[1] Redline Revision Dated February, 2011

[2] Redline Revision Dated July 19, 2011

MD 117 (W.DIAMOND AVE) AND I-270 SOUTHBOUND RAMP

HAZARD IDENTIFICATION BEACON

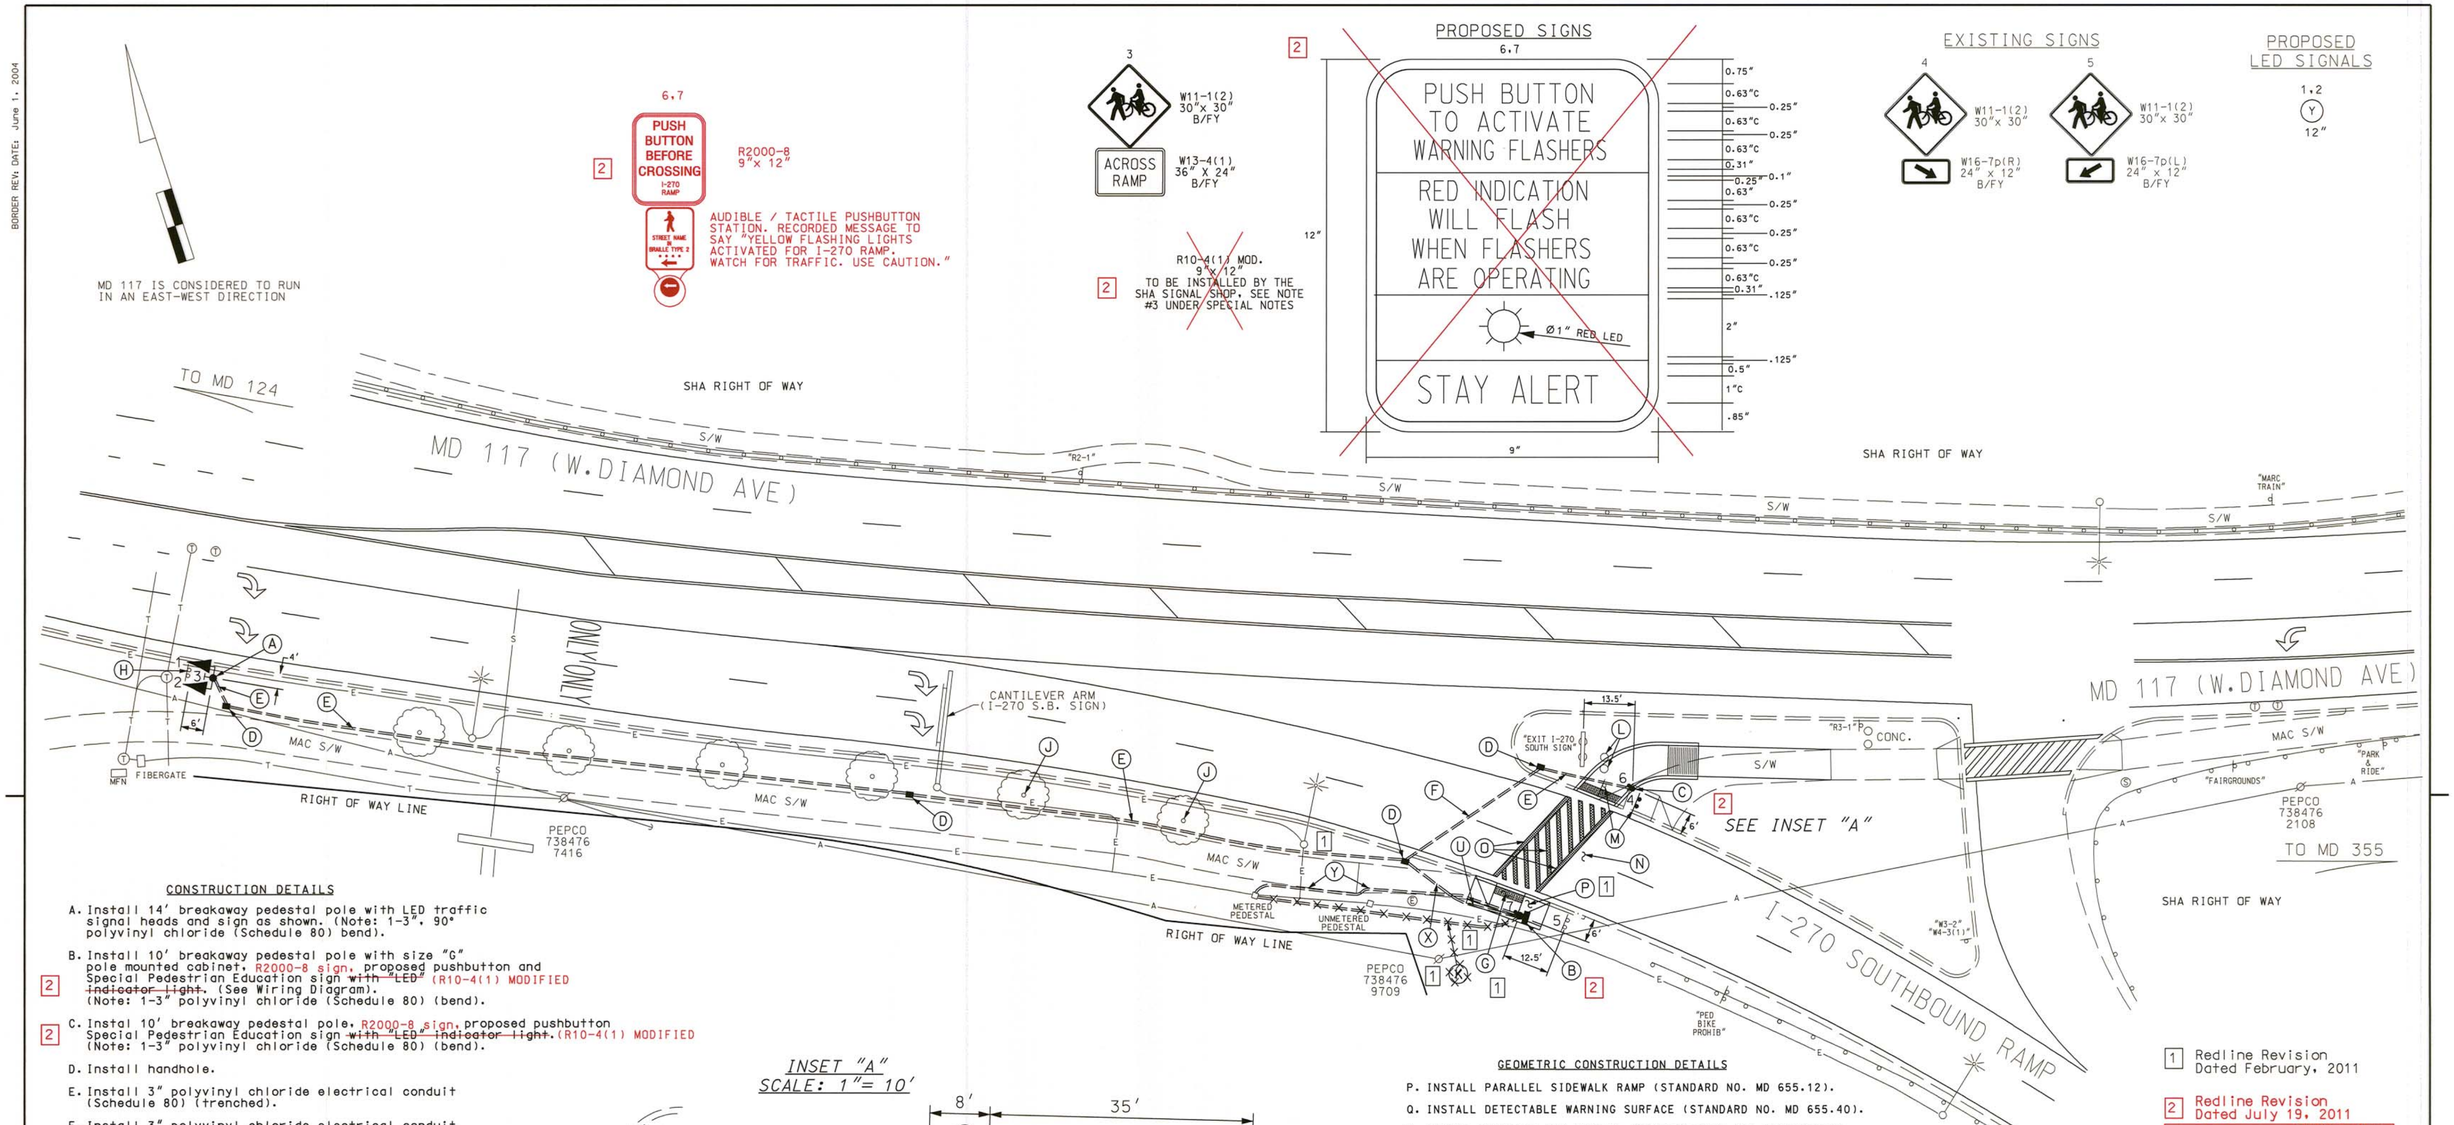
B. Install 10' breakaway pedestal pole with size "G" pole mounted cabinet, R2000-8 sign, proposed pushbutton and Special Pedestrian Education sign ~~with "LED" indicator light~~. (R10-4(1) MODIFIED (See Wiring Diagram). (Note: 1-3" polyvinyl chloride (Schedule 80) (bend). [2]

C. Instal 10' breakaway pedestal pole, R2000-8 sign, proposed pushbutton Special Pedestrian Education sign ~~with "LED" indicator light~~. (R10-4(1) MODIFIED (Note: 1-3" polyvinyl chloride (Schedule 80) (bend). [2]

[1] ~~K. Install 3" polyvinyl chloride electrical conduit (Schedule 80) (trenched) (for power service). Use existng metered pedestal.~~

[1] X. Remove existing sidewalk and install 3" polyvinyl chloride electrical conduit and (Schedule 80) (trenched).

[1] Y. Remove existing necessary sidewalk to install 3" polyvinyl chloride electrical conduit (Schedule 80) (trenched) (for power service). Use existng metered pedestal.
